Access Compliance Report

Public Rights-of-Way

(Pedestrian Signals)

Intersection ID: N/A	Main Street:	Cross Street: N/A	Location: N/A
ADA ID: 4ABF4DB7B510	Signal Type: One Push Button-Non APS	Overall Compliance: No	Severity Score: BTN 1: N/A BTN 2: N/A No BTN: N/A
Codes/Mitigation Info/Possible Solution		Field Measurements/Component Compliance

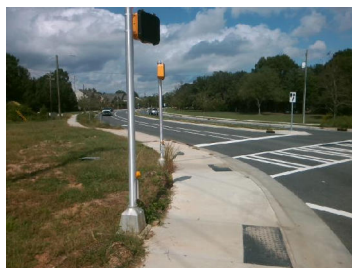
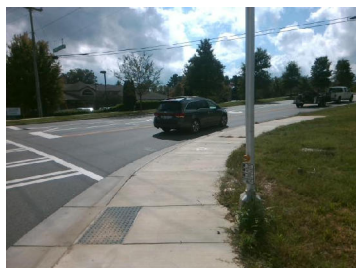
PROW/ADA: TMUTCD 4e.08

Yes	B 1 Clear Xing Direction?	ClearlyMarked	N/A	B 2 Clear Xing Direction?	N/A
	B 1 Crossing Direction	To SE		B 2 Crossing Direction	N/A
Yes	B 1 DistanceTo XWalk (in)	14.0	N/A	B 2 DistanceTo XWalk (in)	N/A
No	B 1 DistanceTo Curb (in)	86.0	N/A	B 2 DistanceTo Curb (in)	N/A
Yes	B 1 Diameter (in)	2.0	N/A	B 2 Diameter (in)	N/A

Possible Solutions: Replace Signal Push Button With APS Button on New Post. Remove & Relocate Sign.
